PARTS & SERVICE NEWS

REF NO.	AA02242
DATE	November 4, 2002

SUBJECT: AIR SYSTEM HOSE DAMAGE DUE TO IMPROPER CLAMPING

APPLICATION: Komatsu HD785-5LC Dump Trucks A10254 thru A10291

PREVIOUS HOSE CLAMP	REPLACEMENT TWO-PIECE HOSE CLAMP
VN9913	Clamp (04434-53411)
	Cushion (07095-30627)

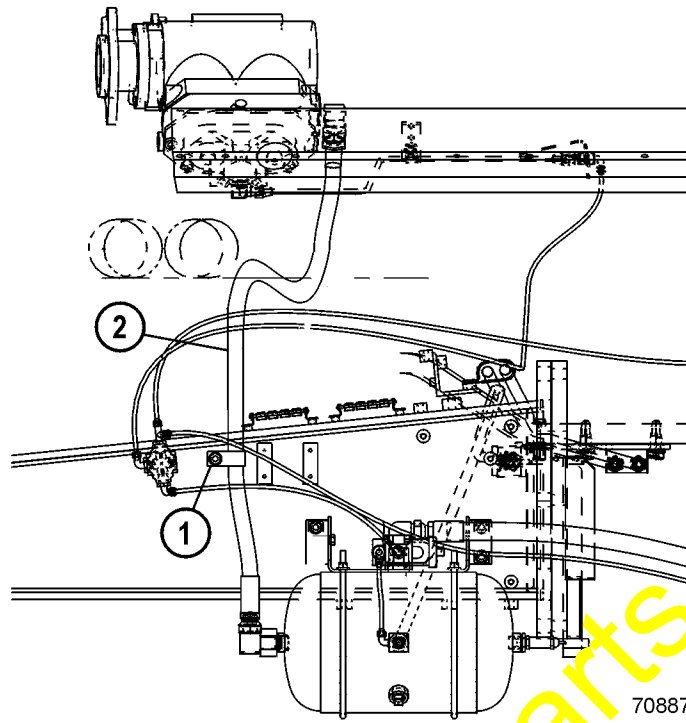
Some trucks in the field may experience hose damage to the wire-braided hose that connects the air compressor to the air tank. In most cases, this damage can be attributed to chafing between hose (2) and hose clamp (1). *NOTE: Figure 1 applies to units A10271 thru A10274. Figure 2 applies to all other units.*

A two-piece replacement clamp is available to replace the current clamp. Replace clamp (VN9913) with clamp (04434-53411) and cushion (07095-30627). Use the existing hardware to secure the clamp. An inspection of the hose should be performed during clamp replacement. Replace as necessary.
